UNITED STATES PATENT AND TRADEMARK OFFICE

APPLICATION NO.	FILING DATE	FIRST NAMED INVENTOR	ATTORNEY DOCKET NO.	CONFIRMATION NO.
10/814,331	04/01/2004	Ray C. Minor	P69605US0	5342
136	7590	02/28/2006	EXAMINER	
JACOBSON HOLMAN PLLC 400 SEVENTH STREET N.W. SUITE 600 WASHINGTON, DC 20004			BURCH, MELODY M	
			ART UNIT	PAPER NUMBER
			3683

Office Action Summary

DETAILED ACTION

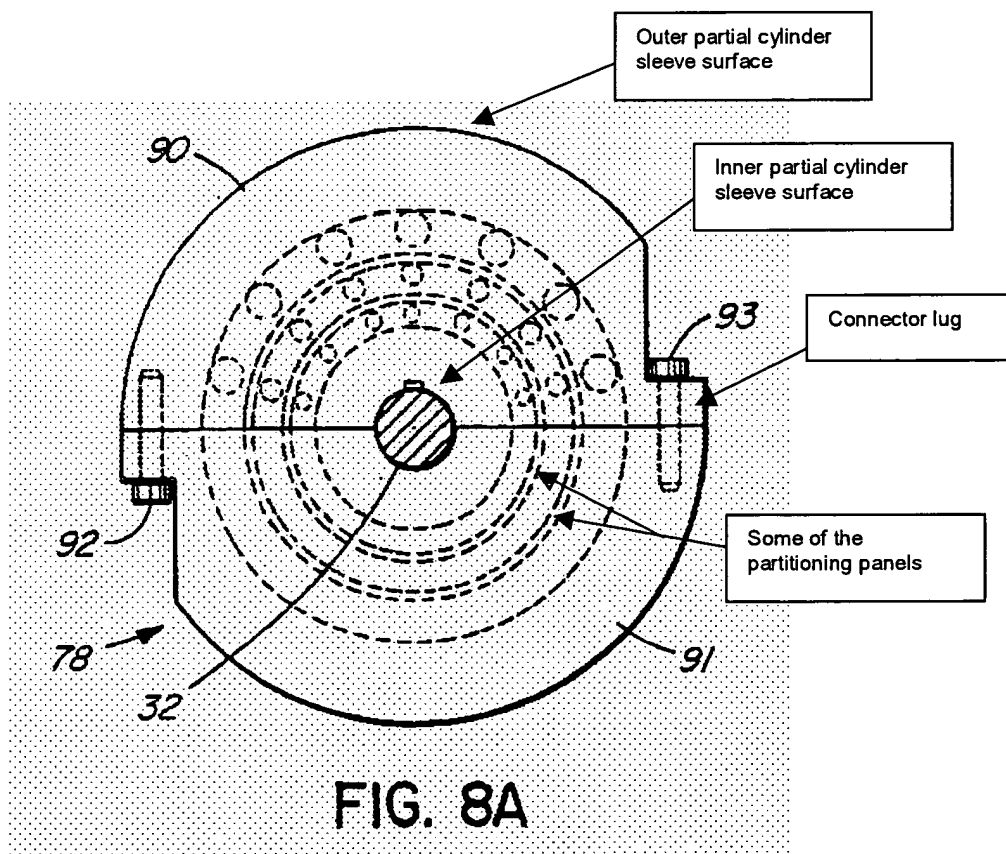
Re: claims 33, 37, and 38. Hannah et al. show in figure 8A pole a vibration damping assembly mountable on a pole 32 capable of damping wind induced first harmonic mode pole vibrations, said assembly comprising an annular housing including a first housing component half-portion 90 and a second housing component half-portion 91 and connections 92, 93 connecting the first housing component half-portion to the second housing component half-portion, each housing component half-portion including an inner partial cylinder having an inner partial cylinder sleeve surface as labeled in the

drawing on the following page having a lower portion, a center of curvature and being dimensioned and shaped to fit in a mating manner over, and in facing contact with, an upper end portion of a pole having an axis approximately coextensive with the center of curvature of the pole as shown, an outer partial cylinder sleeve positioned outwardly of the inner partial cylinder sleeve surface and having a lower end portion and a center of curvature that is coextensive with the center of curvature of the inner partial cylinder sleeve surface as shown, a floor panel shown below the balls extending between lower portions of the inner partial cylinder sleeve surface and the outer partial cylinder sleeve, a plurality of partitioning panels shown radially between the balls extending vertically upwardly from the floor panel and extending between the inner partial cylinder sleeve and the outer partial cylinder sleeve to define damping weight receiving chambers between adjacent partitioning panels and a movable damping weight or balls in each of the damping weight receiving chambers as shown.

Hannah et al. show some of the partitioning panels, but fail to show the damping weight receiving chambers being non-circular.

Re: claims 44, 45, and 50. Hannah et al., as modified, show in figure 8a a vibration reducing device mountable on a pole 32 capable of damping wind induced first harmonic mode vibrations comprising a housing mountable on a pole and including an annular array of dry weight receiving chambers or annular areas in which the balls are located shaped and dimensioned to encircle and effect mounting of the device on a pole, a damping weight or spherical balls in each dry weight receiving chamber and, wherein, the dry weight receiving chambers are separated by structure or partitioning panels as shown preventing movement of the damping weights from one dry weight receiving chamber to an adjacent dry weight receiving chamber.

Re: claims 41-43. Hannah et al., as modified, show in figure 8A wherein the first housing component half-portion and the second housing component half-portion are fixedly connected together to cooperatively encircle the cylindrical pole, each housing component half portion includes a first planar plate extending between a first end portion of the inner partial cylinder sleeve and a connector lug labeled in the labeled version of figure 8A found earlier in the office action comprising part of the connection on a first end portion of the outer partial cylinder sleeve, and a second planar panel

extending between a second end portion of the inner partial cylinder sleeve and a connector lug as labeled comprising part of the connection on a second end portion of the outer partial cylinder sleeve and threaded screws comprising part of the connection connecting the connector lug of the second housing component half portion to provide a rigid housing structure.
